TECHNICAL MANUAL
TYPING AND NONTYPING REPERFORATORS
TELETYPE MODEL 14

CHANGES
No. 1 }

DEPARTMENT OF THE ARMY
WASHINGTON 25, D. C., 24 June 1949

TM 11-2223, 15 September 1947, is changed as follows:

Figure 41.1 (Added.) Lubrication points, side view of range finder (Order Nos. 9838-Phila-48 and 14700-Phila-49).

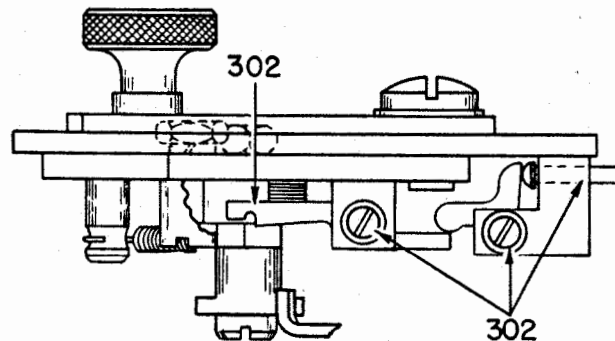
Figure 41. Lubrication points, selector and platen mechanism. (Figure 41.1 shows lubrication points on side of range finder furnished on Order Nos. 9838-Phila-48 and 14700-Phila-49.)

Figure 54.1 (Added.) Selector unit (pulling magnet) (Order Nos. 9838-Phila-48 and 14700-Phila-49).

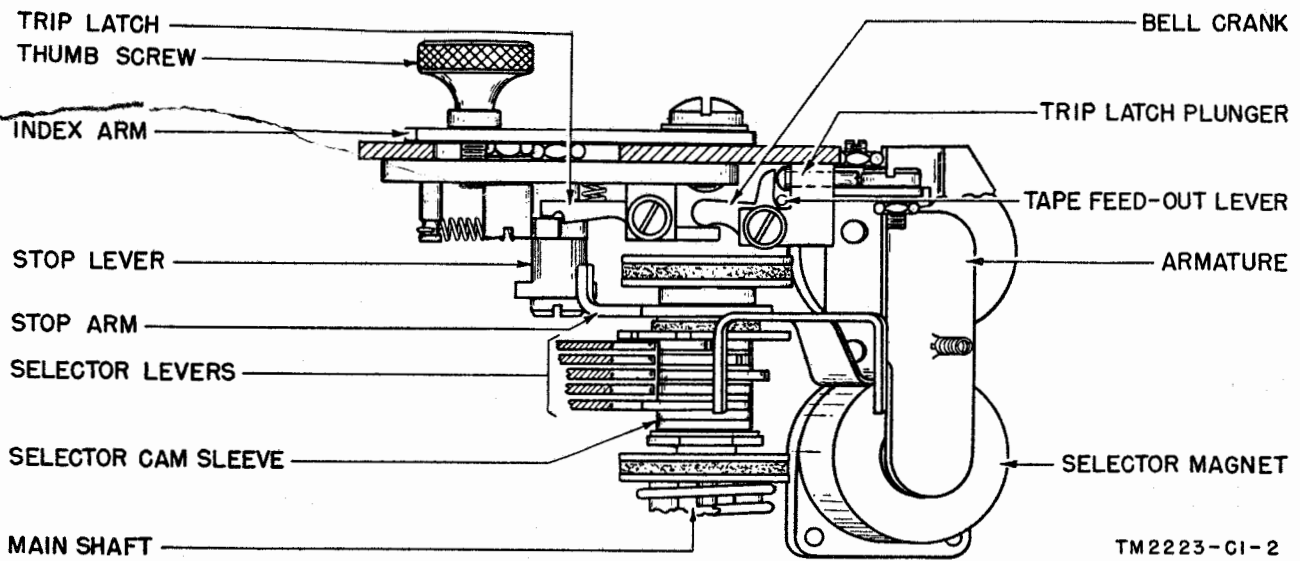
Figure 54. Selector unit (pulling magnet). (Figure 54.1 shows the selector unit (pulling magnet) furnished on Order Nos. 9838-Phila-48 and 14700-Phila-49.)

Figure 57.1 (Added.) Selector unit (holding magnet) (Order Nos. 9838-Phila-48 and 14700-Phila-49).

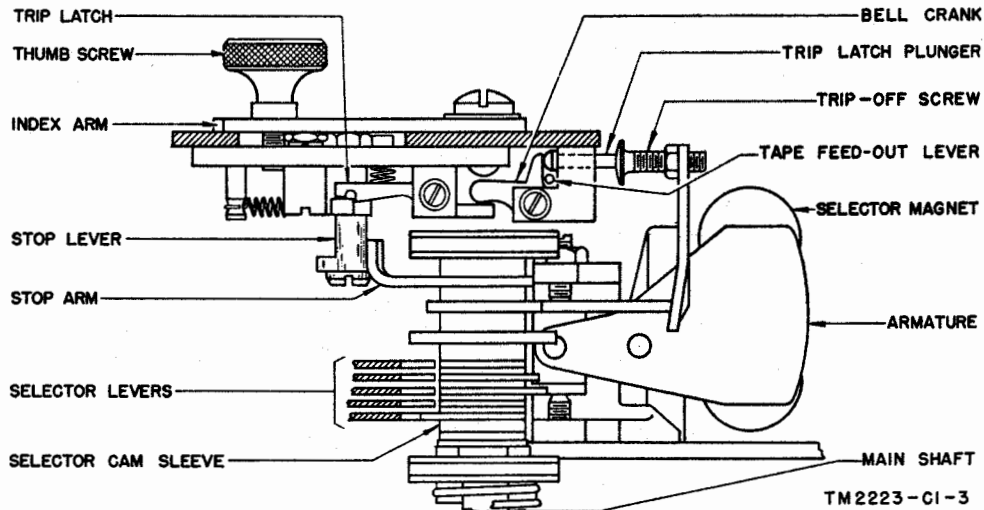
Figure 57. Selector unit (holding magnet). (Figure 57.1 shows the selector unit (holding magnet) furnished on Order Nos. 9838-Phila-48 and 14700-Phila-49.)

Figure 142.1 (Added.) Stop-lever eccentric stud requirements (Order Nos. 9838-Phila-48 and 14700-Phila-49).

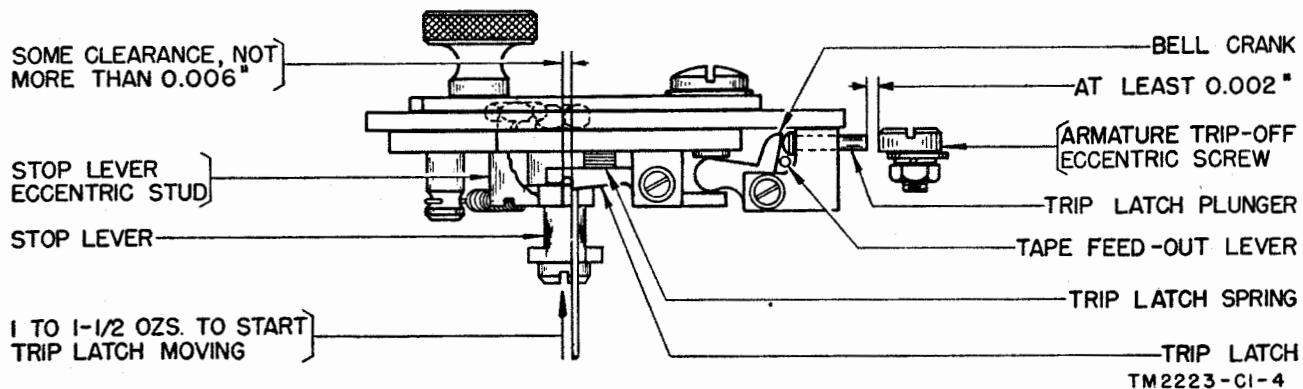
b. REQUIREMENTS. The stop lever * * * to 0.006-inch. With equipments procured on Order Nos. 9838-Phila-48 and 14700-Phila-49 the overtravel should be not more than 0.006 inch.

Figure 142. Stop-lever eccentric stud requirements. Figure 142.1 shows the requirements for equipments on Order Nos. 9838-Phila-48 and 14700-Phila-49.)

Figure 144.1. (Added.) Armature trip-off eccentric-screw requirements (Order Nos. 9838-Phila-48 and 14700-Phila-49).

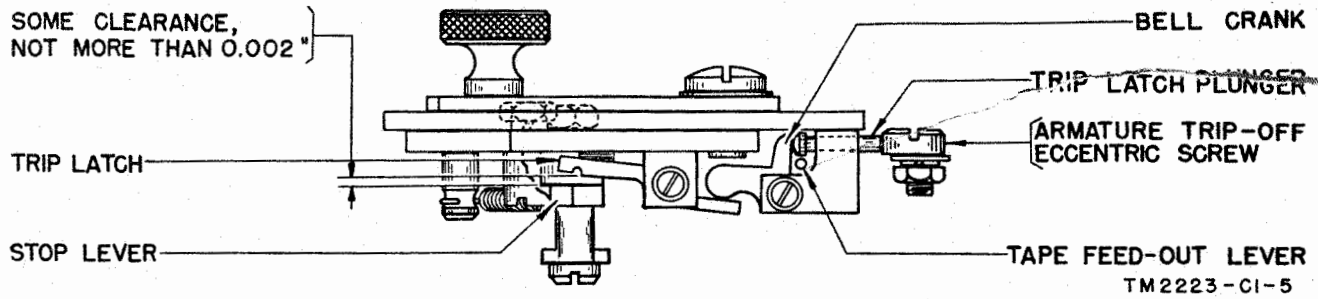
Figure 144. Armature trip-off eccentric-screw requirements. (Figure 144.1 shows requirements for equipments on Order Nos. 9838-Phila-48 and 14700-Phila-49.)

Figure 153.1 (Added.) Stop lever eccentric stud requirements (Order Nos. 9838-Phila-48 and 14700-Phila-49).

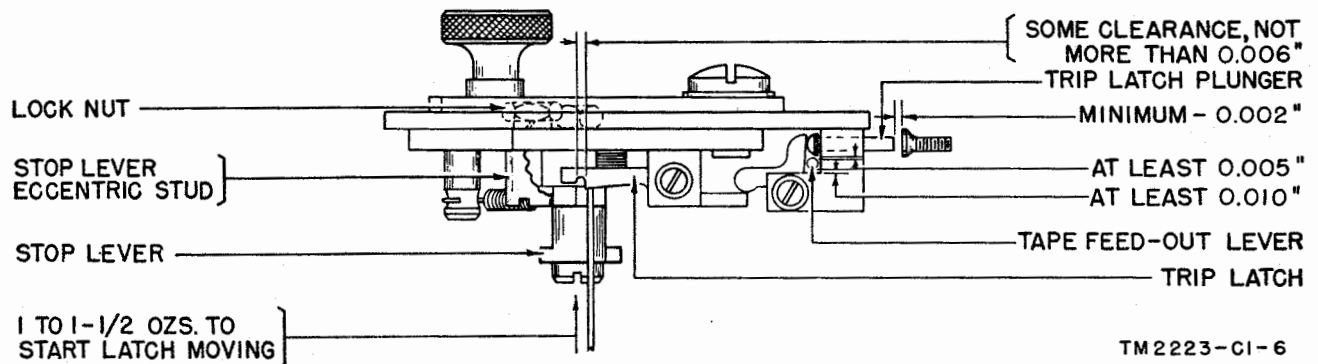
Figure 153. Stop-lever eccentric stud requirements. (Figure 153.1 shows requirements on Order Nos. 9838-Phila-48 and 14700-Phila-49.)

b. REQUIREMENTS. The stop lever * * * 0.004-inch to 0.006-inch. With equipment procured on Order No. 9838-Phila-48 the stop lever on the range-finder assembly should overtravel the latching face of the trip latch by not more than 0.006 inch.

Figure 154.1 (Added.) Trip-off screw requirements (Order No. 9838-Phila-48).

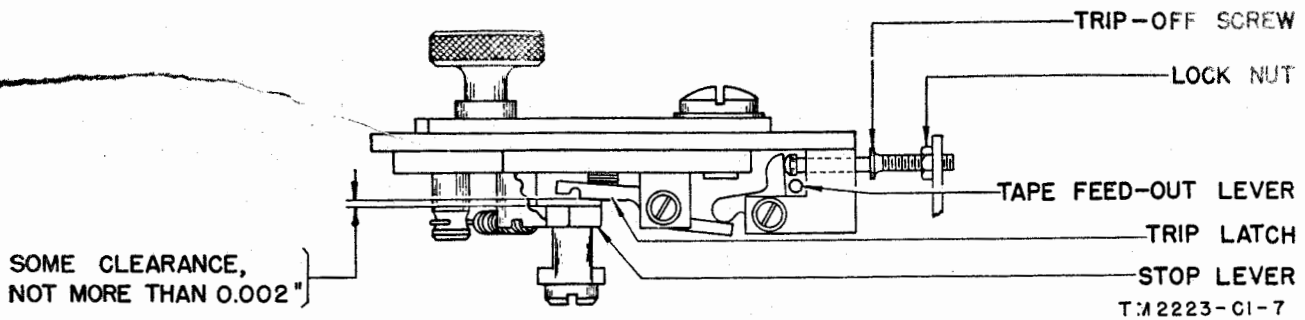
Figure 154. Trip-off screw requirements. (Figure 154.1 shows requirements for equipment on Order Nos. 9838-Phila-48 and 14700-Phila-49.)

Figure 176. (Superseded.) Code-bar bell crank requirements.

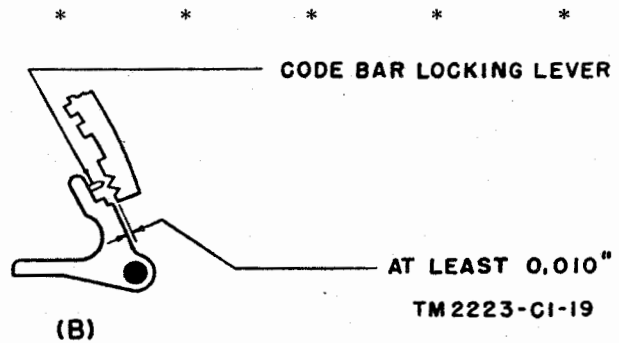
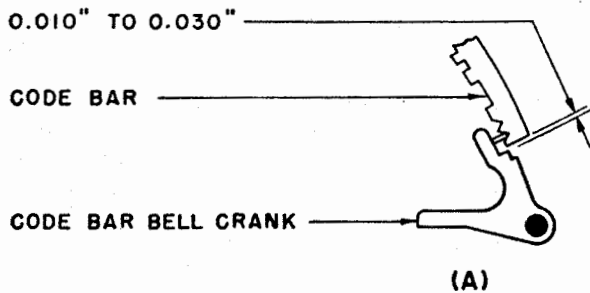
- (1) The code bars * * * crank separator plates.
- (2) The code-bar bell * * * associated bell cranks. With equipments procured on Order Nos. 9839-Phila-48 and 14700-Phila-49 the code-bar bell cranks (fig. 176) should meet the following requirements: With the code-bars positioned for BLANK selection and the locking lever resting against the code bars, there should be 0.010-inch to 0.030-inch clearance between the right ends of the code

bars and the adjacent edges of the associated code-bar bell cranks.

- (3) The code-bar bell * * * code-bar bell cranks. With equipments procured on Order Nos. 9838-Phila-48 and 14700-Phila-49 the code-bar bell cranks (fig. 177) should meet the following requirements: With the code bars positioned for BLANK selection, rotate the main shaft until the right ends of the code bars and the adjacent parallel edges of the associated code-bar bell cranks are at the point of closest approach. Under this condition the clearance at this point should be 0.010 inch to 0.030 inch.

TM 2223-CI-8
Figure 217.1 (Added.) Top view of range finder (Order No. 9799-Phila-48).

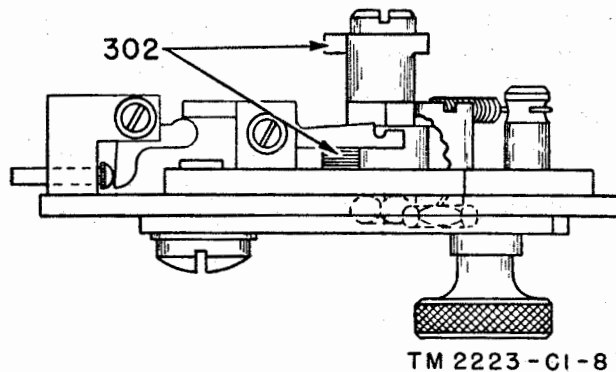
Figure 217. Treatment of nontyping reperforator. (Figure 217.1 illustrates the top view of range finder furnished with equipment on Order No. 9799-Phila-48.)

Figure 220.1 (Added.) Cross-section of selector mechanism (Order No. 9799-Phila-48).

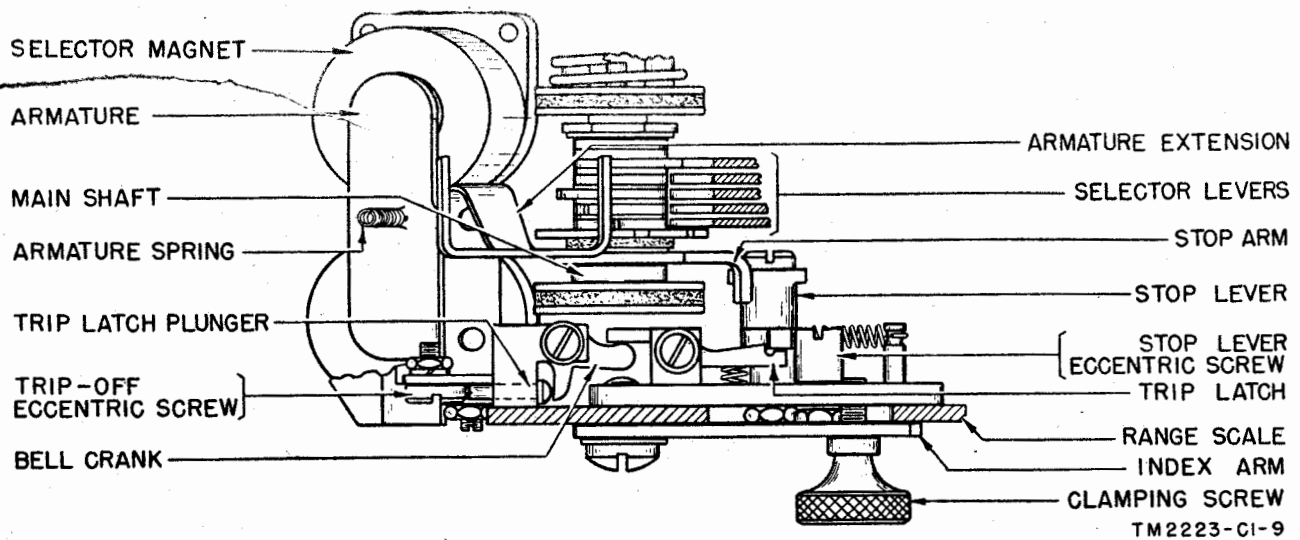
Figure 220. Cross-section of selector mechanism. (Figure 220.1 shows cross-section of selector mechanism on Order No. 9799-Phila-48.)

Figure 241.1 (Added.) Stop-lever eccentric screw requirements (Order No. 9799-Phila-48).

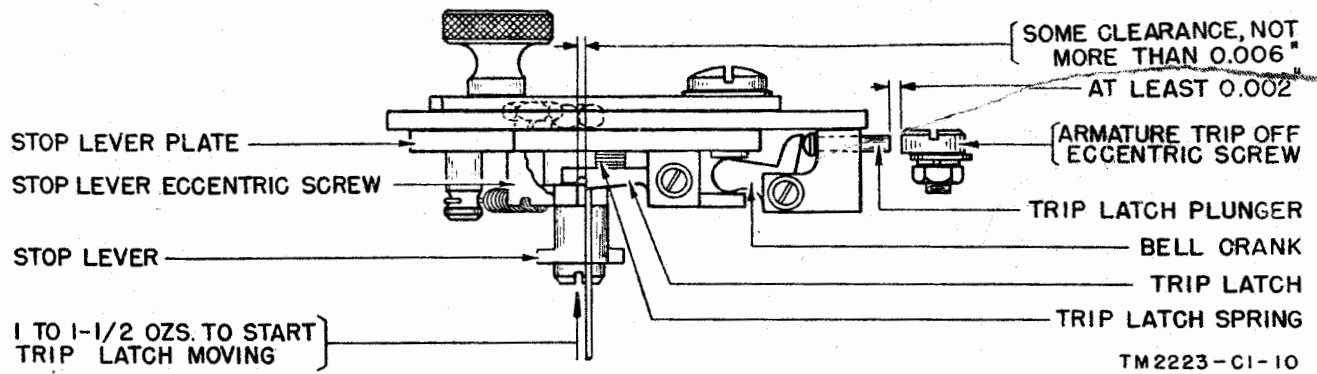
b. REQUIREMENTS. The stop lever * * * to 0.006 inch. With equipments procured on Order No. 9799-Phila-48 the stop lever on the range-finder assembly should overtravel the latching surface of the trip latch by not more than 0.006 inch.

Figure 241. Stop-lever eccentric screw requirements. (Figure 241.1 shows the stop-lever screw requirements on Order No. 9799-Phila-48.)

Figure 243.1 (Added.) Armature trip-off eccentric-screw requirements (Order No. 9799-Phila-4).

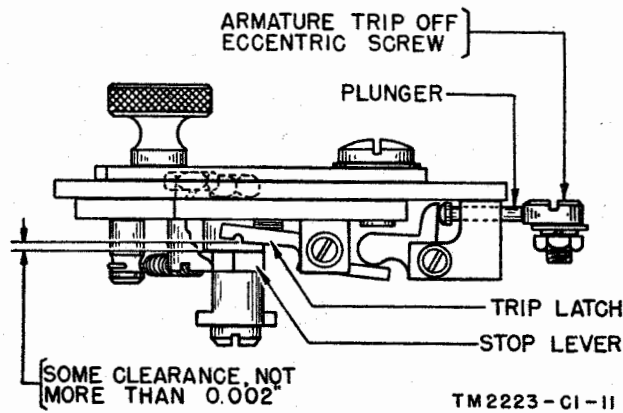
Figure 243. Armature trip-off eccentric-screw requirements (Figure 243.1 shows the armature trip-off eccentric-screw requirements on Order No. 9799-Phila-48).

Figure 254.1 (Added.) Space-out lever requirements (Order No. 9799-Phila-48).

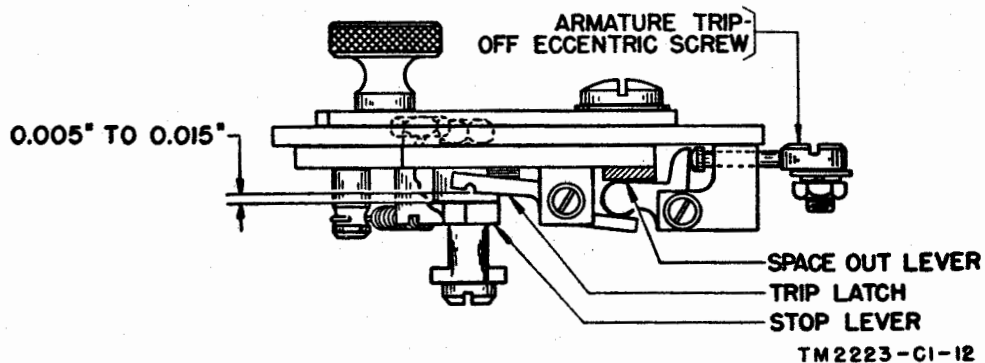
Figure 254. Space-out lever requirements (Figure 254.1 shows space-out lever requirements on Order No. 9799-Phila-48).

Figure 262.1 (Added.) 11024 punch-block assembly (Order Nos. 9838-Phila-48 and 14700-Phila-49).

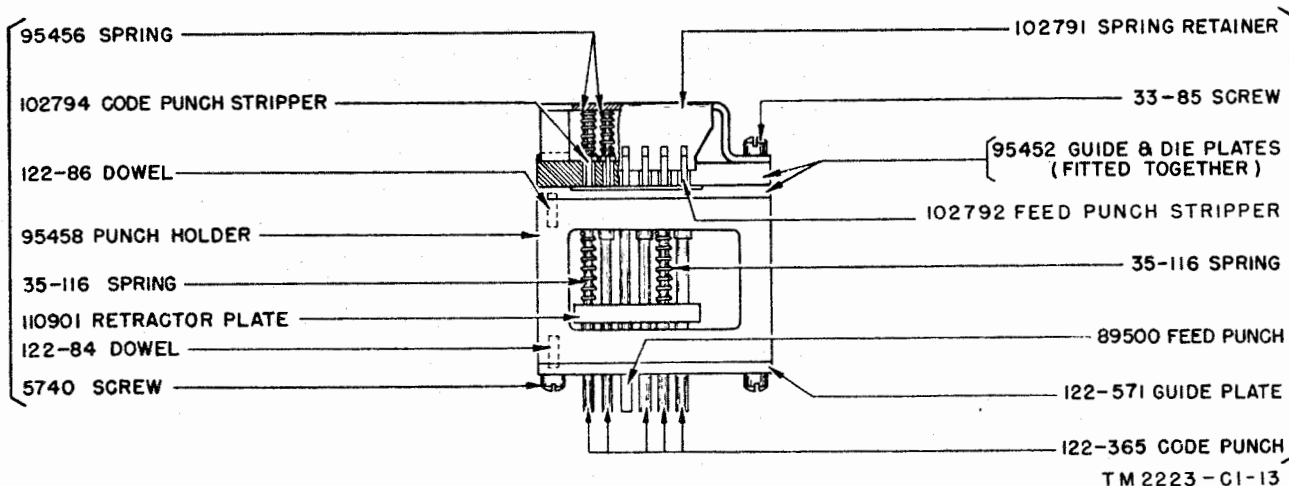
Figure 262. Punch block and punch-block bracket parts (FPR5, FPR17, FPR21, and FPR23). (For equipments on Order Nos. 9838-Phila-48 and 14700-Phila-49 make the following changes: In the top illustration change the designation 84023 to read: 110974. Change the designation ©122-577 Feed Roll to read: ©110682. Under the designation ©81598 Bushing add: Not Required. In the center illustration change the designation 35-88 to read: 2421. Change the designation 85355 Tape Plate to read: 85355 Tape Plate For FPR5 and FPR21, or 98702 Tape Plate For FPR23. Delete the bottom illustration and substitute figure 262.1 which shows the 11024 Punch Block Assembly.)

Figure 266.1 (Added.) Main-shaft bearing retainer.

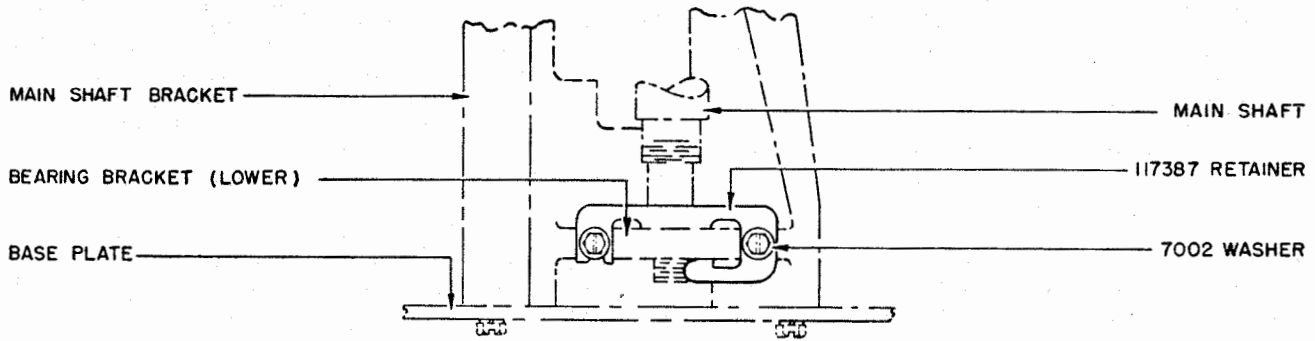
Figure 266. Main-shaft parts (FPR5, FPR17, FPR21, and FPR23). (For equipments on Order Nos. 9838-Phila-48 and 14700-Phila-49 change the designation 82440 Screw to read: 74986 Screw. Delete the 36-24 Pin. Delete the designation 96763 Shim-0.012" Thick, 96764 Shim-0.016" Thick, and 96765 Shim-0.020" Thick.)

Figure 268.1 (Added.) 90760 range scale (assembly) (Order Nos. 9838-Phila-48 and 14700-Phila-49.

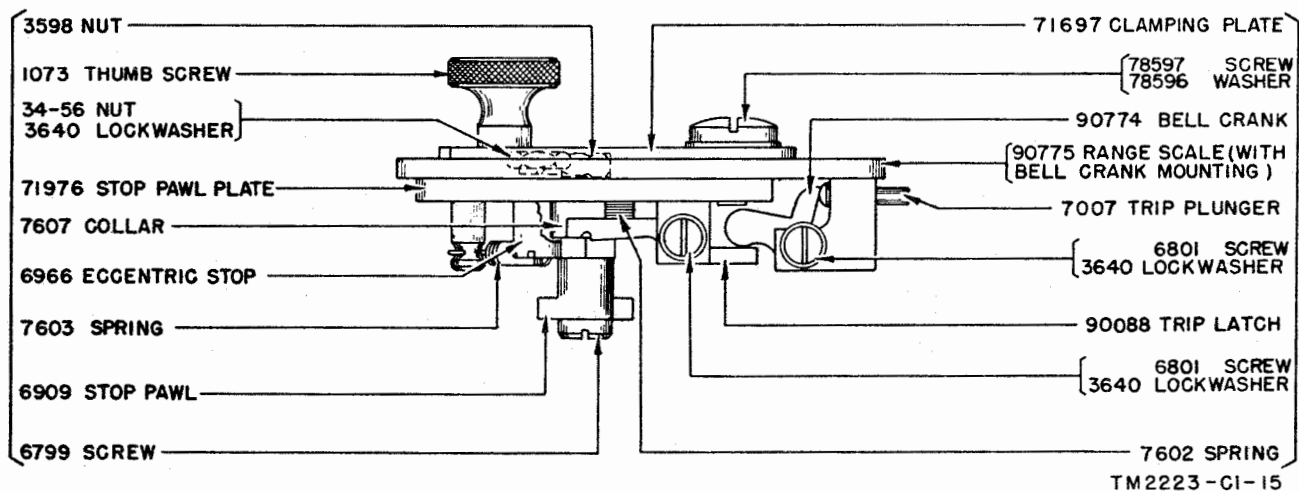
Figure 268. Bell bracket, range scale, and ribbon-feed unit parts (FPR5, FPR17, FPR21, and FPR23). (For equipments on Order Nos. 9838-Phila-48 and 14700-Phila-49 make the following changes: In the upper illustration delete the designation 2669 Lockwasher. In the center illustration delete the designation 90760 Range Scale (Assembly) (For Use With Holding Magnet Selector). (Figure 268.1 illustrates the range scale assembly.)

Figure 302.1 (Added.) 71829 range scale assembly (Order No. 9799-Phila-48).

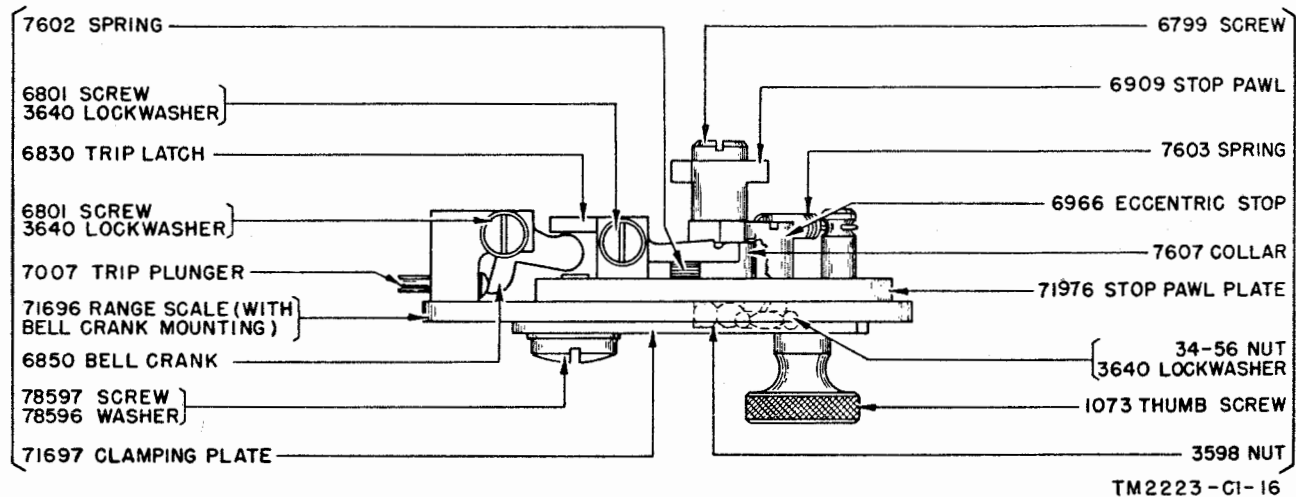
Figure 302, Range scale and punch-block assembly parts (RPE26). (Figure 302.1 shows the 71829 Range Scale Assembly on Order No. 9799-Phila-48. Figure 302.2 shows the 111021 Punch Block Assembly on Order No. 9799-Phila-48.)

Figure 306.1. (Added.) Resistor unit (assembly) (Order No. 9759-Phila-48).

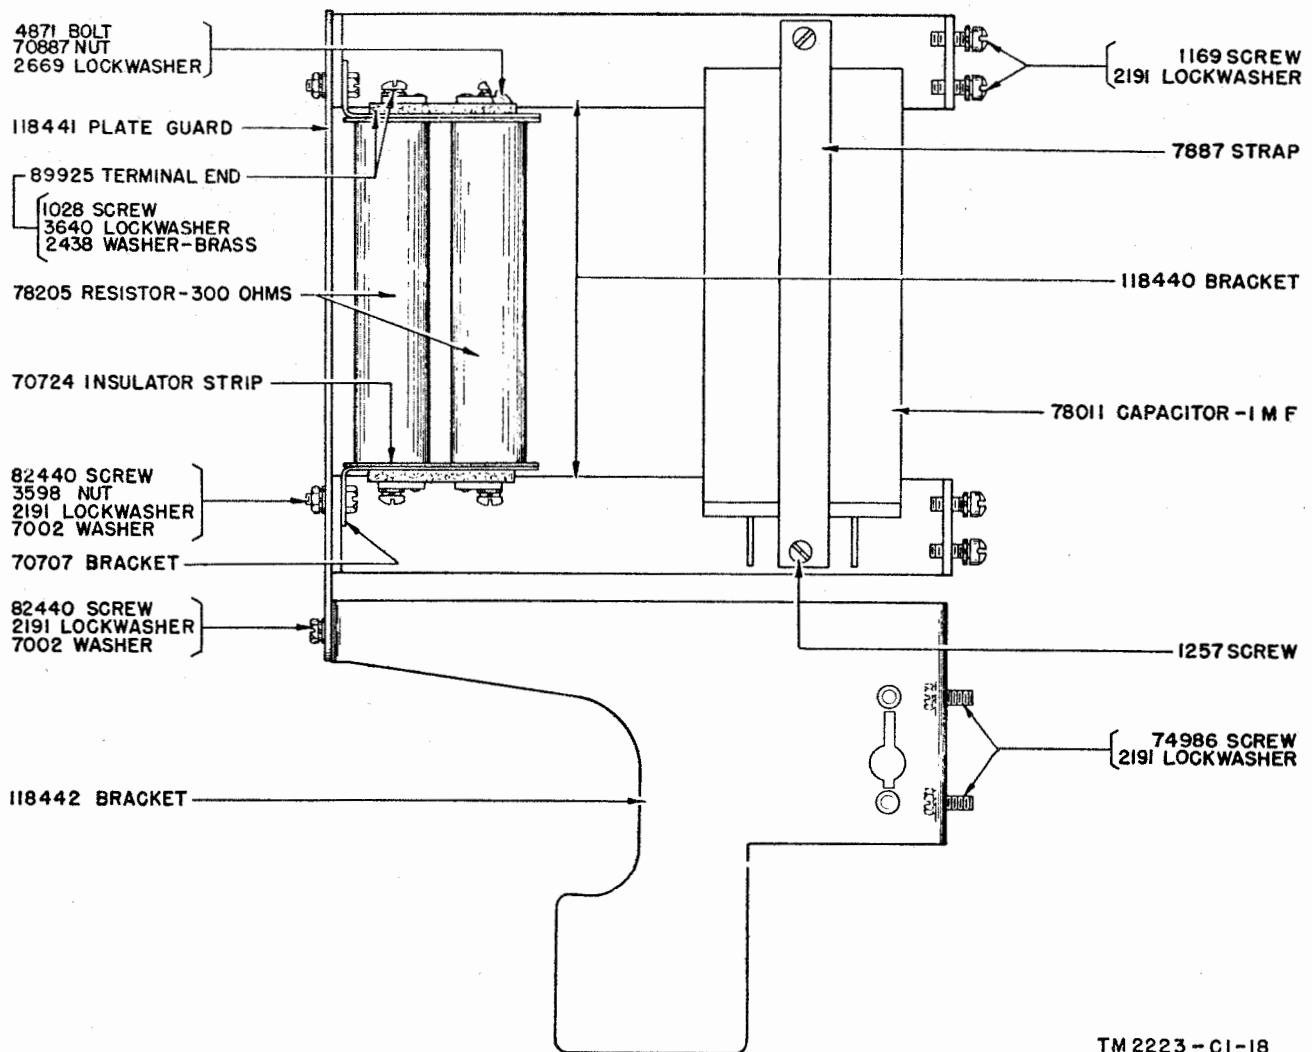
Figure 306. Line-relay radio filter and resistor unit parts (RPE26). (For equipments on Order No. 9799-Phila-48 make the following changes: In the upper illustration change the designation 92229 Line Relay Radio Filter (Assembly) —110 V to read: 111664G Line Relay Radio Filter (Assembly). In the top right-hand illustration exclude the 6810 Screw and 2669 Lockwasher from the 92229 Assembly and show them separately. In the top left-hand illustration, delete the 61-24 Washer-Bakelite and substitute 75750 Washer-Bakelite therefor. Above the 92852 Wire Lead-Orange add a 96202 Wire Lead-Yellow (1½" long) and a 96203 Wire Lead-Yellow (1¾" long). In the center illustration delete the 75436 Resistor-3,000 Ohms (1,000-2,000) and substitute the following therefor: 74614 Resistor-2,600 Ohms (2,000-600). Delete the bottom illustration and substitute figure 306.1 therefor.)
